TOWN HOMES AT

2855 PIERCE STREET HOLLYWOOD FL 33020

FILE NUMBER:20-DP-49

SUBJECT: Final TAC review for a 13-unit residential development
(Pierce Street Affordable Townhomes)

PROPOSED 3RD FLOOR PLAN

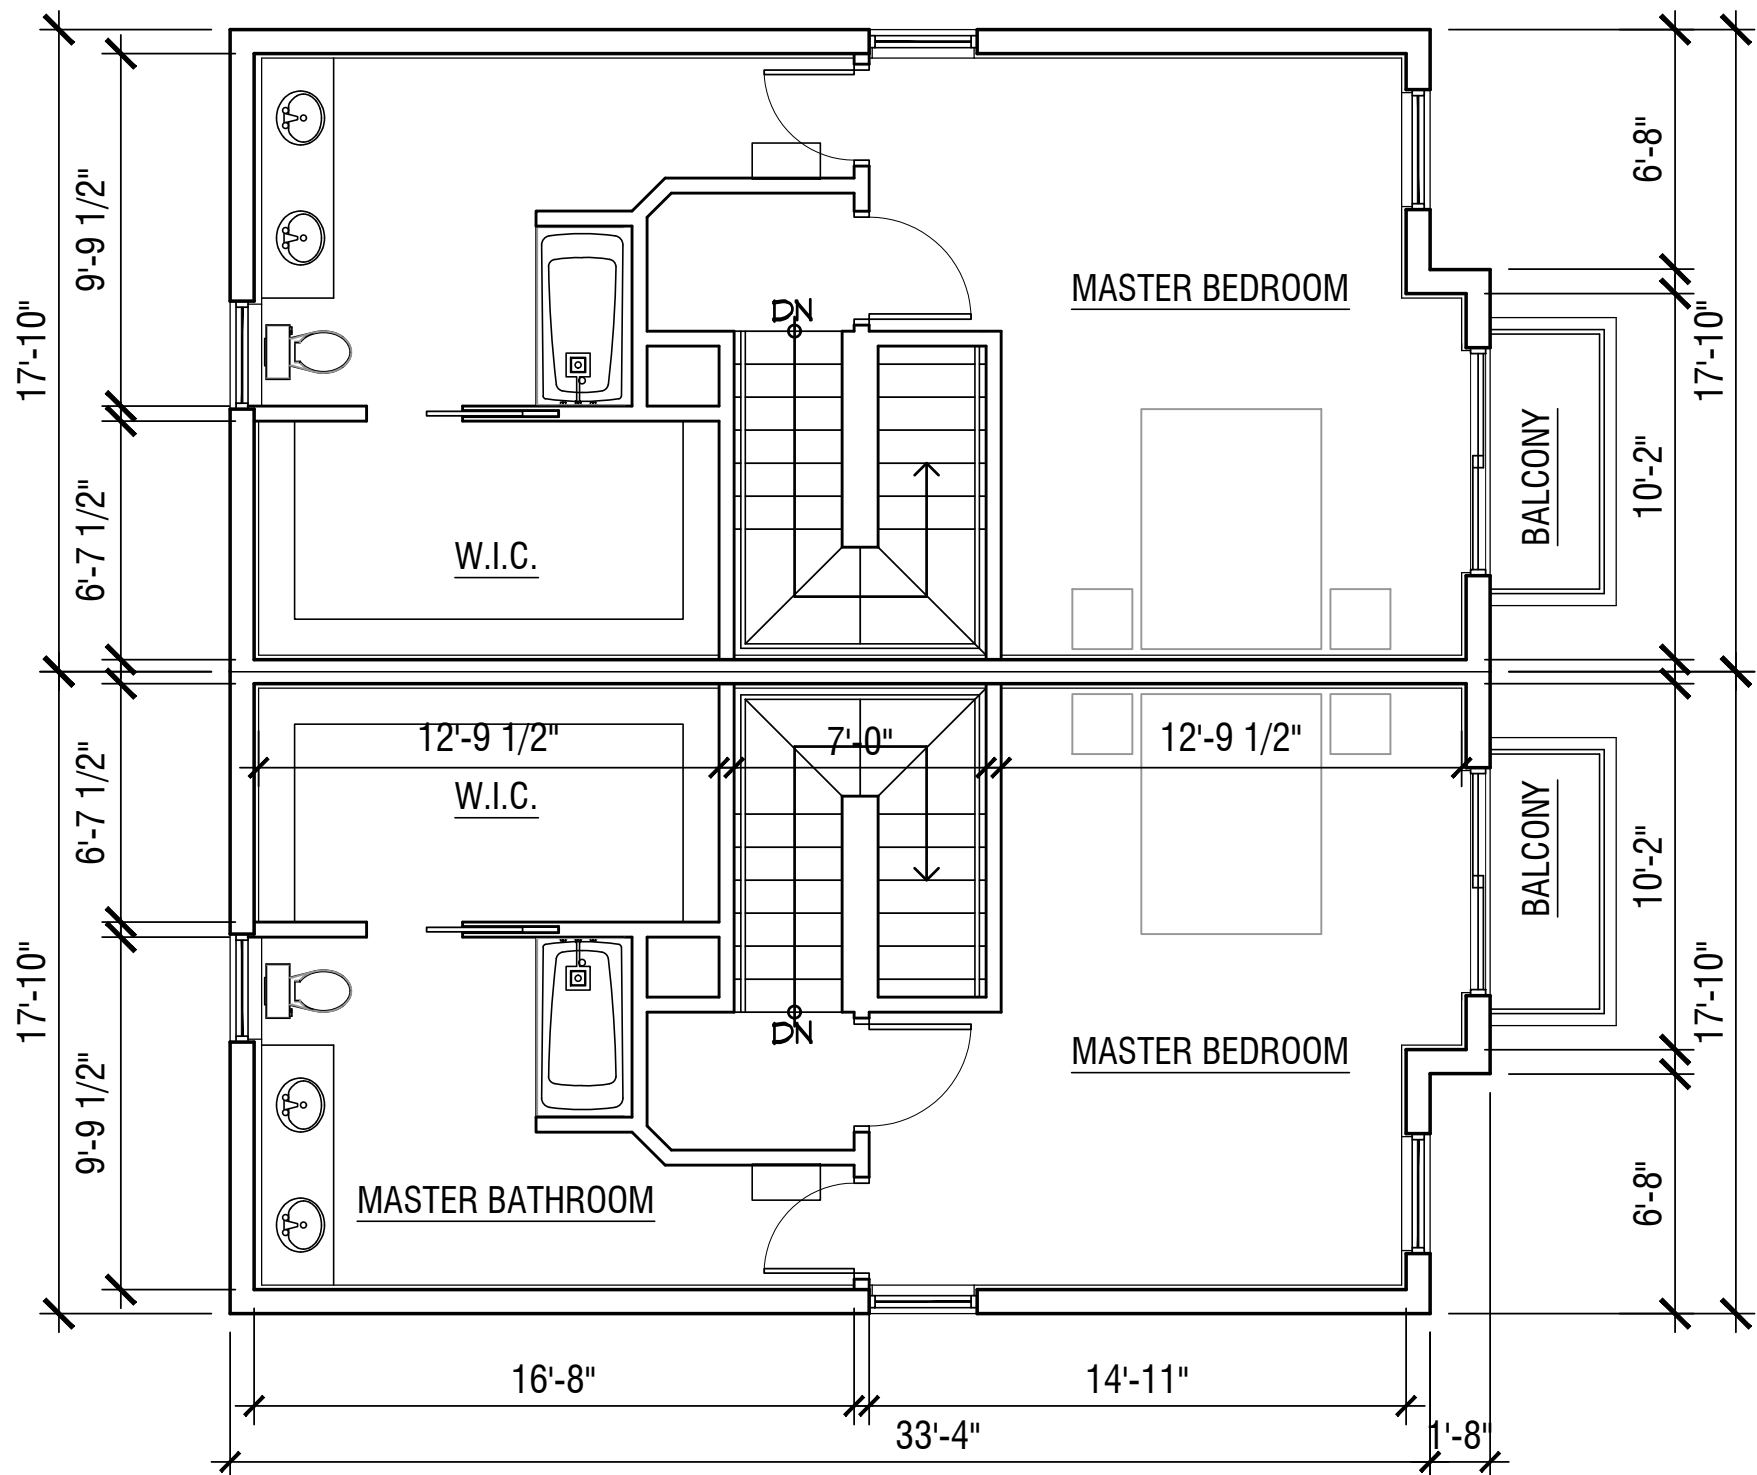
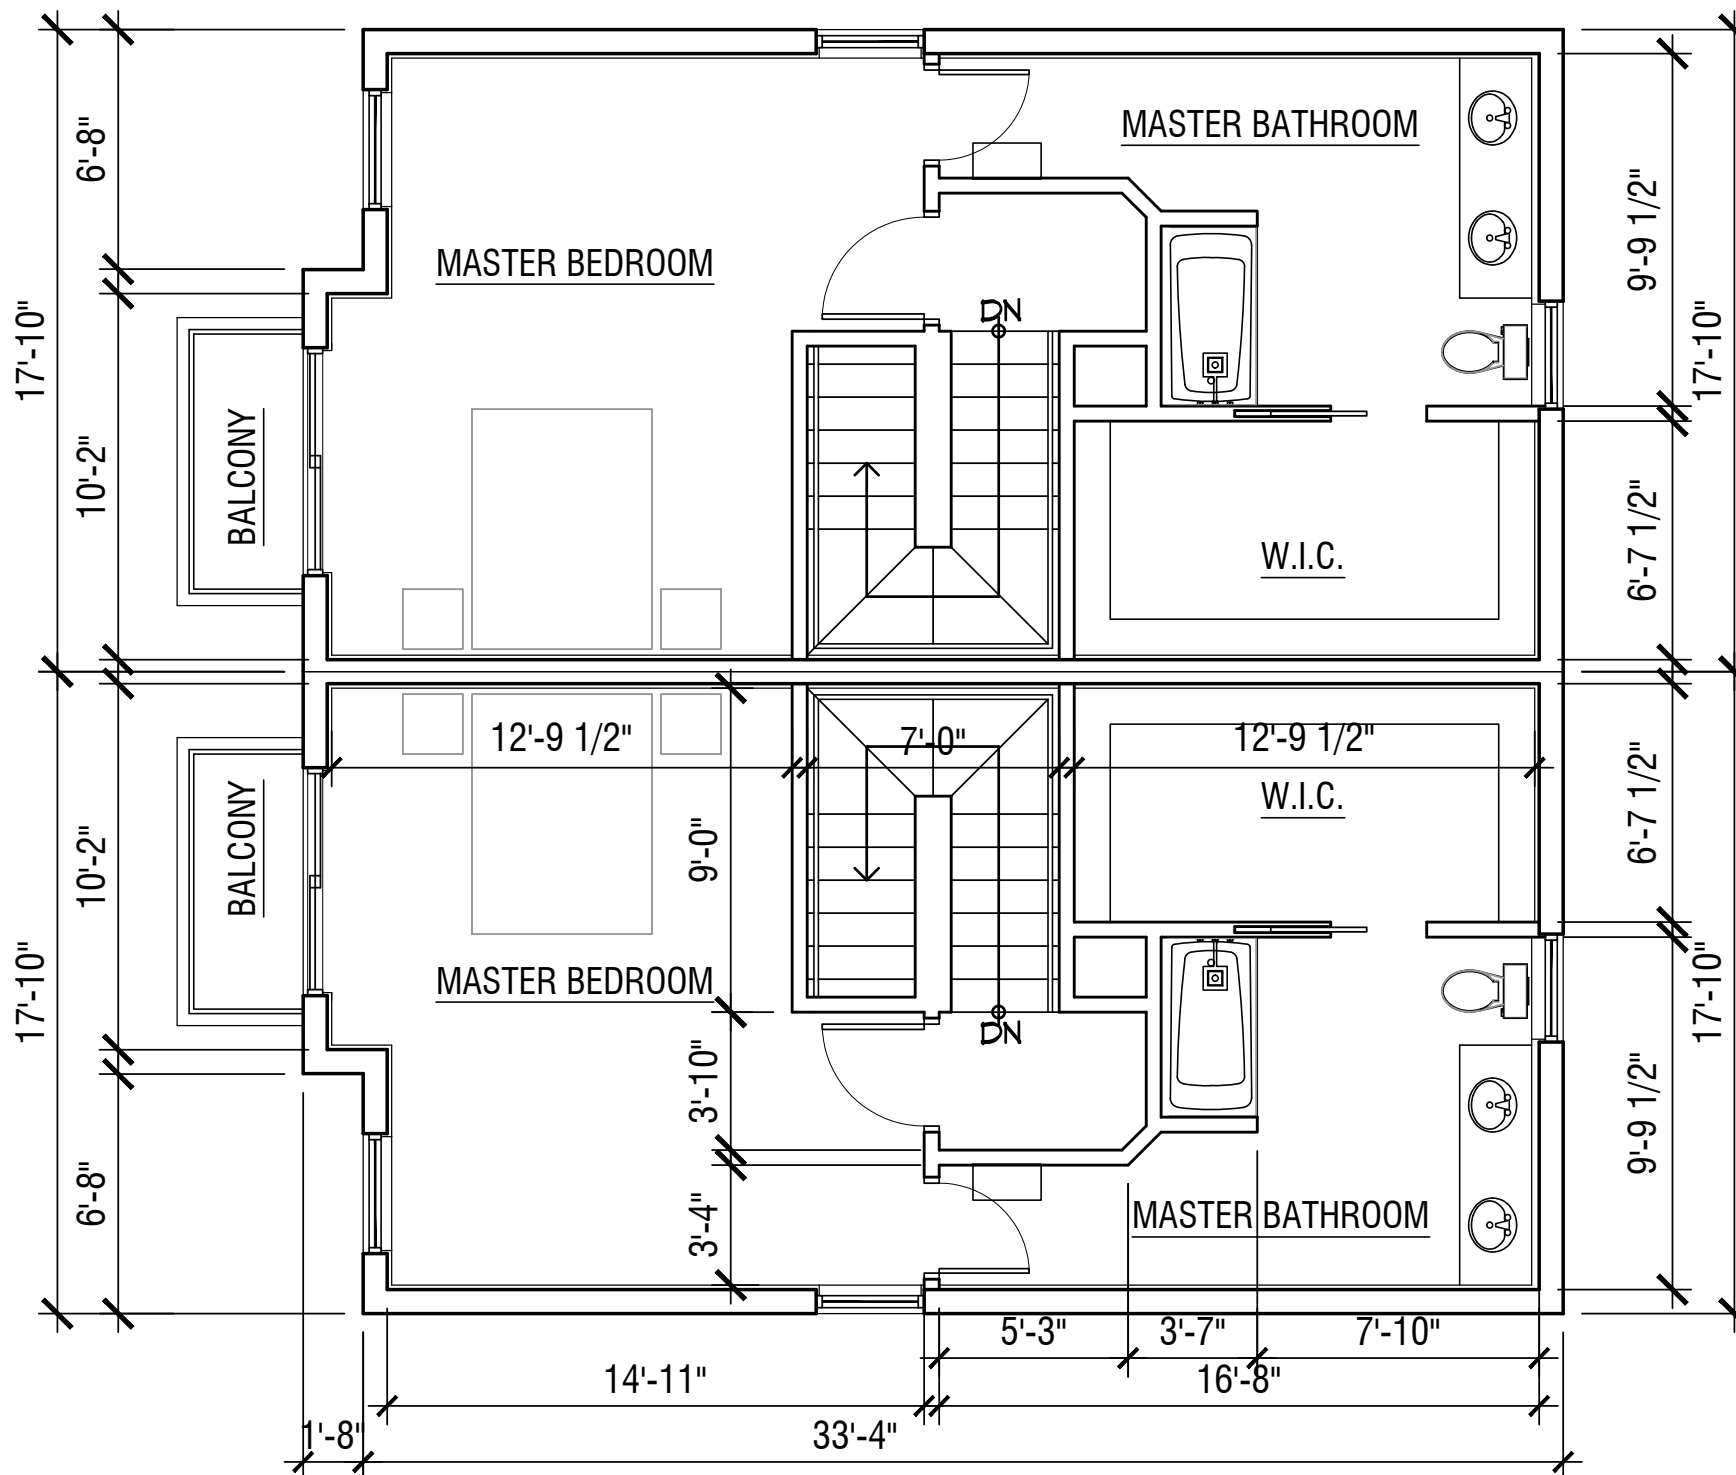
- f. Provide the square footage per floor air-conditioned and non-air-conditioned areas separately.
This is noted on the sheets (A-1, A-2 and A-3) as requested.

PROPOSED MAIN FRONT ELAVATION
3/16" = 1'-0"

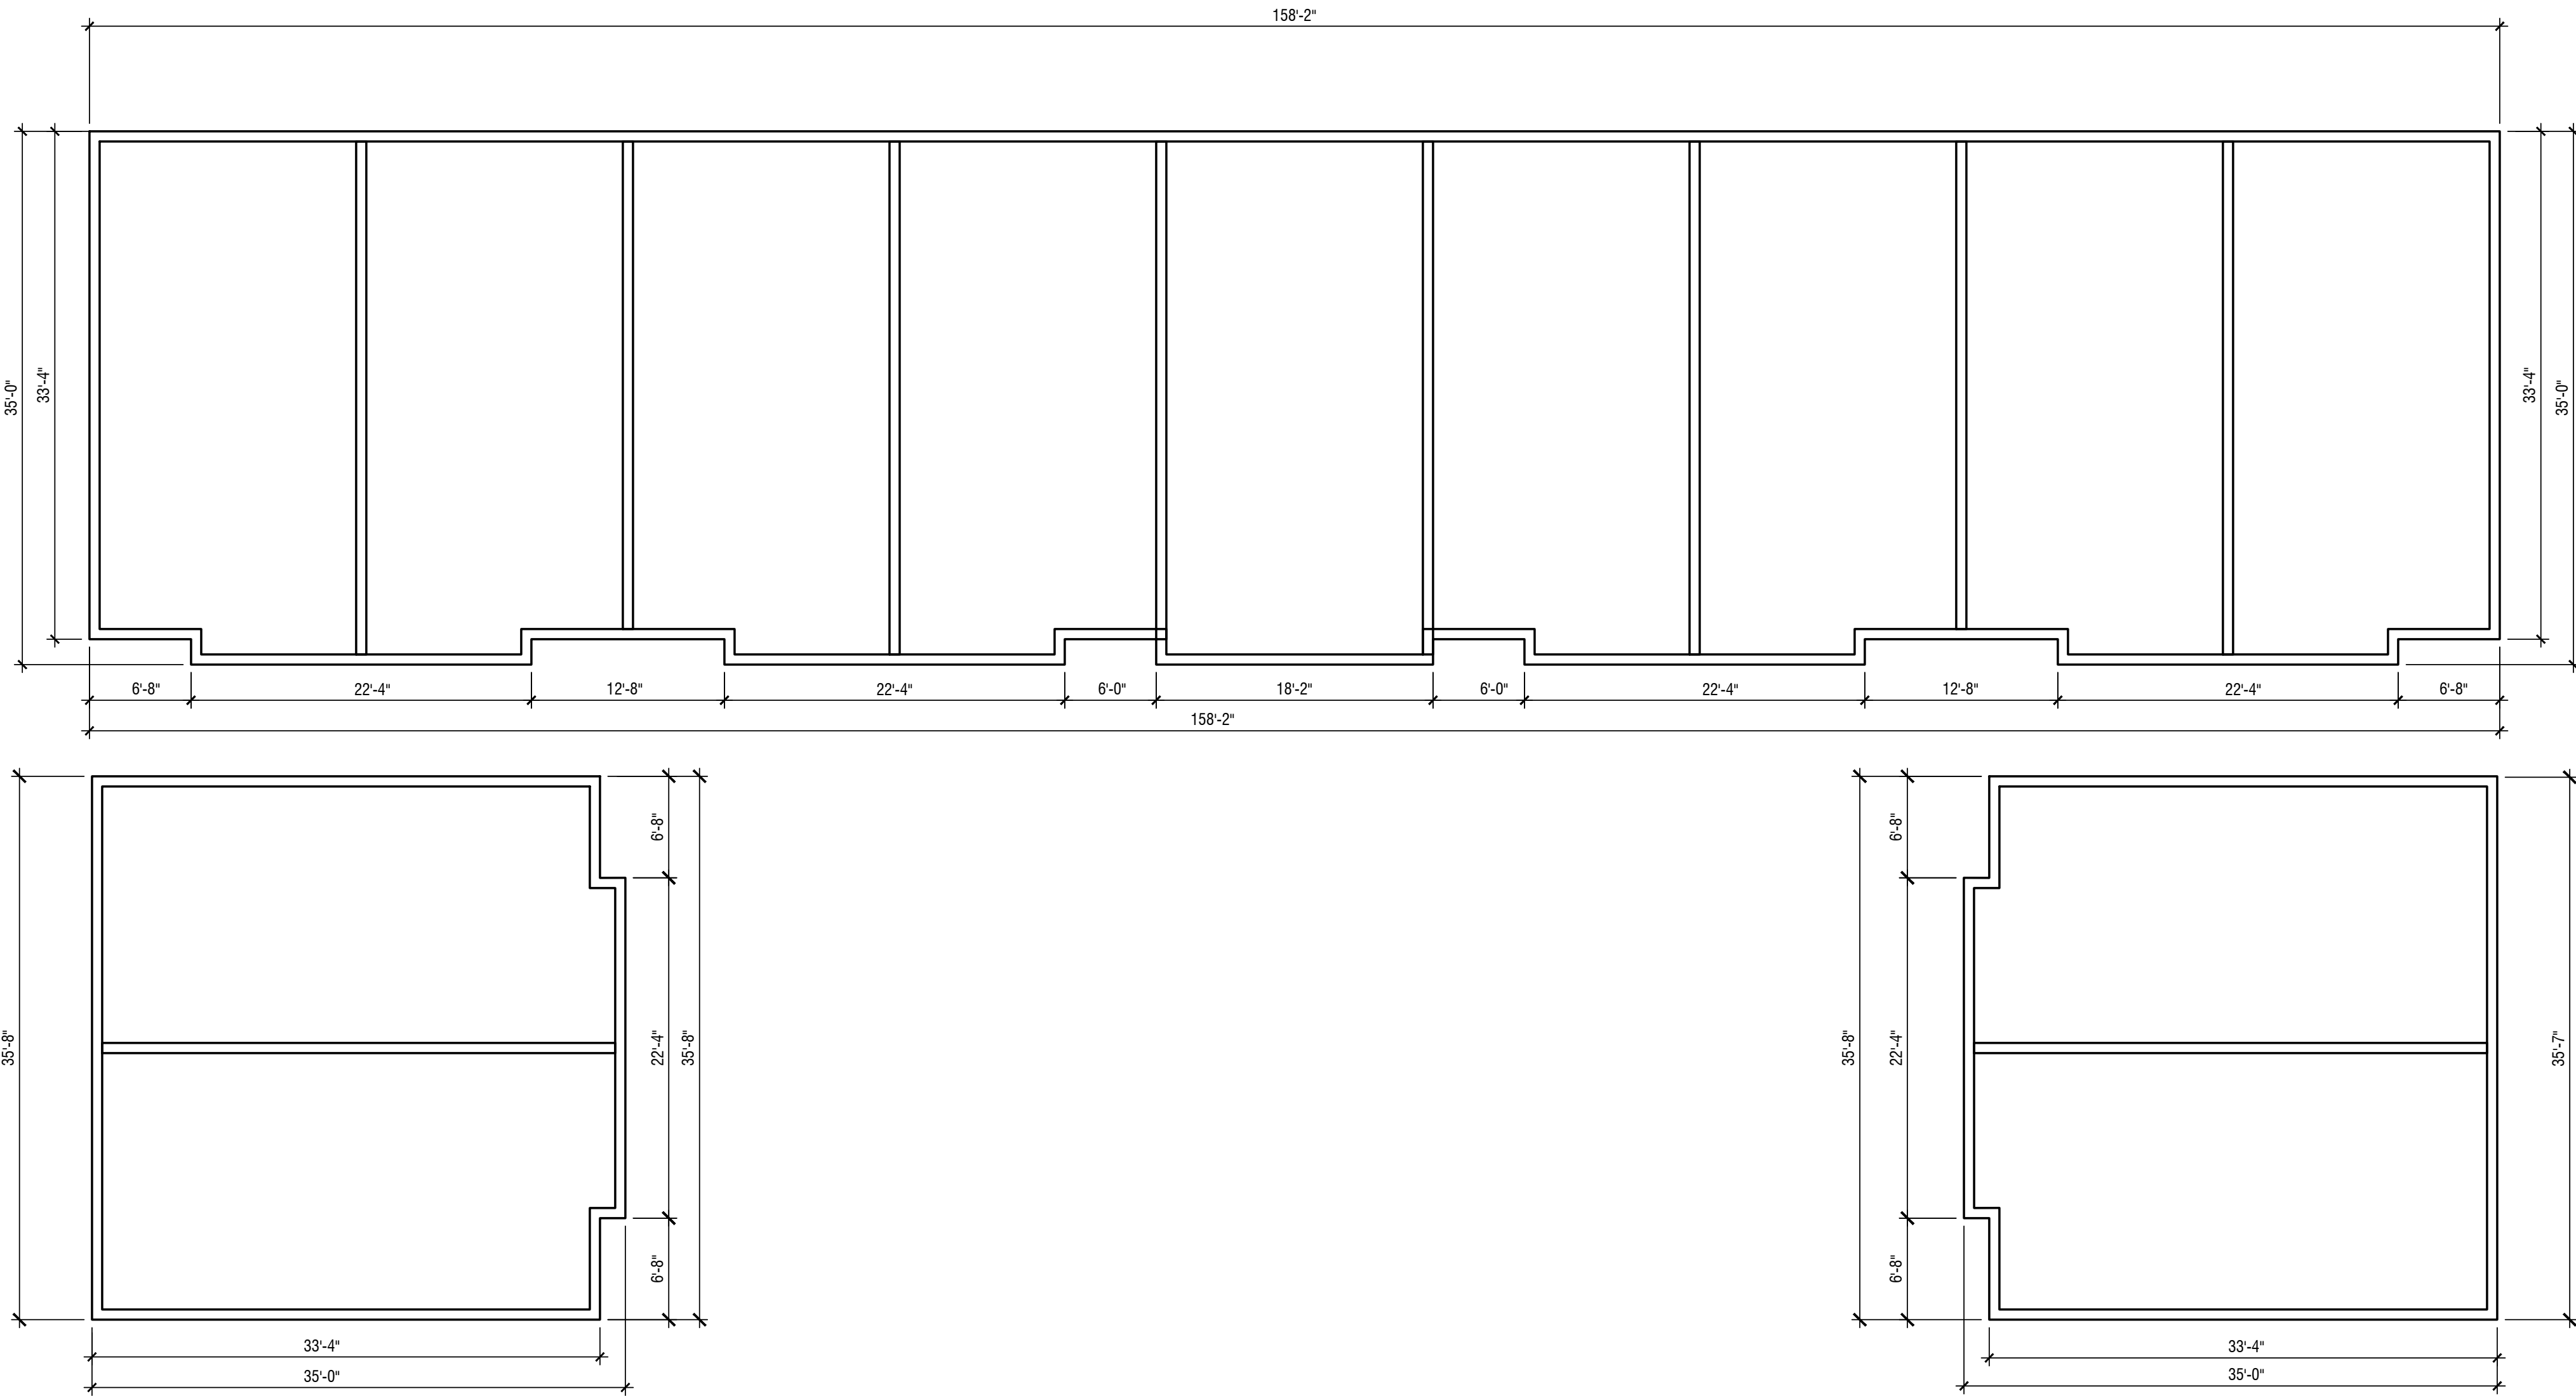
2. Provide a main front elevation from Pierce Street.

This is noted on sheet A-6.
